Access Compliance Report

Public Rights-of-Way

Intersection ID: 9278	Main Street: OAKLAWN_AV	Cross Street: BOOKER_AV	Location: W
ADA ID: D80CEAAD4D00	Ramp Type: Perp	Initial Pass/Fail: Fail	Overall Compliance: No
Severity Score: 31.25			
Codes/Mitigation Info/Possible Solution		Field Measurements/Component Compliance

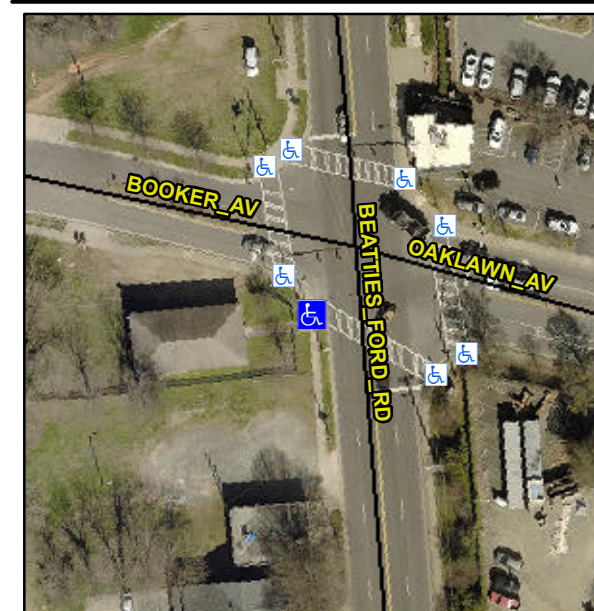
Not Found, R304.5.1, R304.2.2

Compliance	Description	Data	Compliance	Description	Data
N/A	Ramp Length (in)	55.5	No	Ramp Slope (%)	11.5
No	Ramp Width (in)	35.0	Yes	Ramp XSlope (%)	3.0
N/A	Flare Type LT	N/A	N/A	Flare Type RT	N/A
N/A	Flare Slope LT (%)	N/A	N/A	Flare Slope RT (%)	N/A
N/A	Flare Traversable LT?	N/A	N/A	Flare Traversable RT?	N/A
N/A	Landing Length (in)	N/A	N/A	DWS Provided?	N/A
N/A	Landing Width (in)	N/A	N/A	DWS Contrast?	N/A
N/A	Landing Slope (%)	N/A	N/A	DWS Length (in)	N/A
N/A	Landing X Slope (%)	N/A	N/A	DWS Full Width?	N/A
N/A	Landing Curb? (Y/N)	N/A	N/A	DWS Offset (in)	N/A
N/A	Shared Landing?	N/A			
N/A	Gutter Ponding?	N/A	N/A	Gutter Slope (%)	N/A
N/A	Gutter Lip Ht (in)	N/A	N/A	Gutter X Slope (%)	N/A
N/A	Painted X Walk1?	Yes	N/A	Painted X Walk2?	N/A
	X Walk 1 Direction	To SE		X Walk 2 Direction	N/A
N/A	X Walk 1 Width (in)	114.0	N/A	X Walk 2 Width (in)	N/A
	X Walk 1 Slope (%)	3.9		X Walk 2 Slope (%)	N/A
	X Walk 1 X Slope (%)	3.6		X Walk 2 X Slope (%)	N/A

Remove & Replace Entire Ramp.
